PIC18F24/25Q10 Silicon Errata and Data Sheet Clarifications

PIC18F24/25Q10

2. Data Sheet Clarifications

2.1. Pin Diagrams

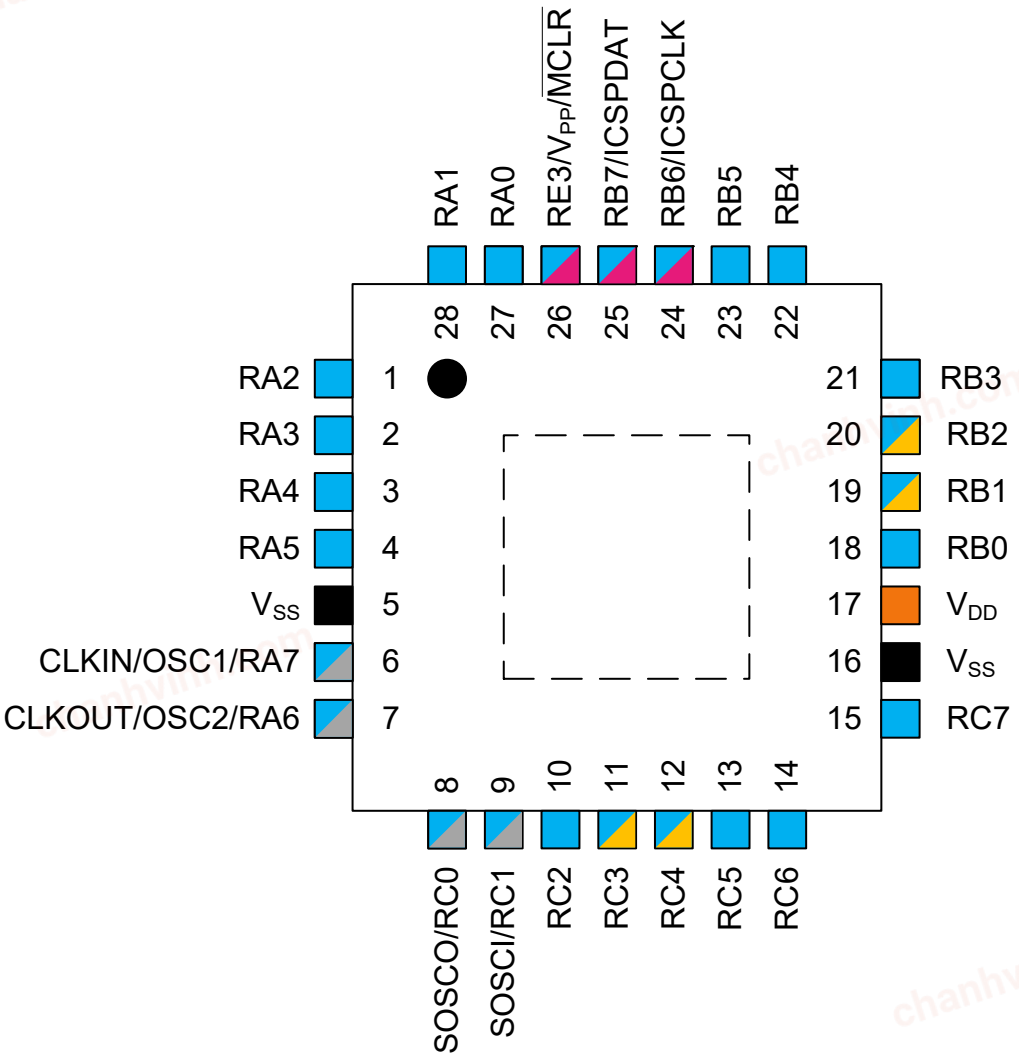
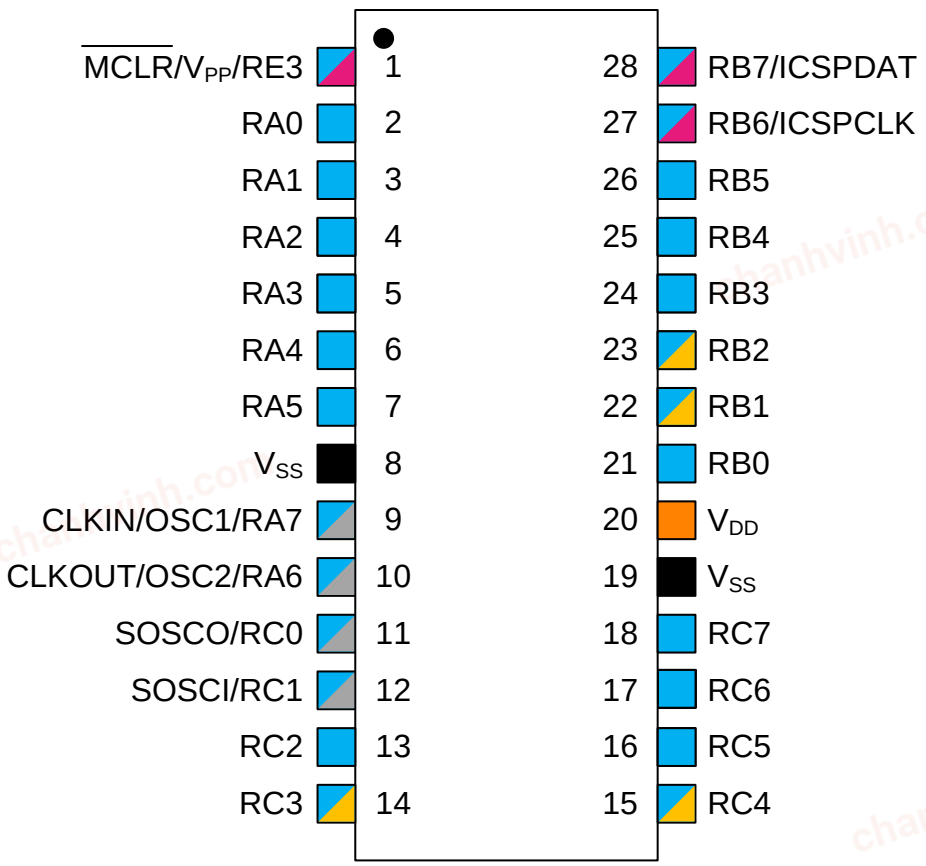
The pin diagrams for the 28-pin packages have changed. Figures 1-1 and 1-2 in the data sheet have been updated as follows:
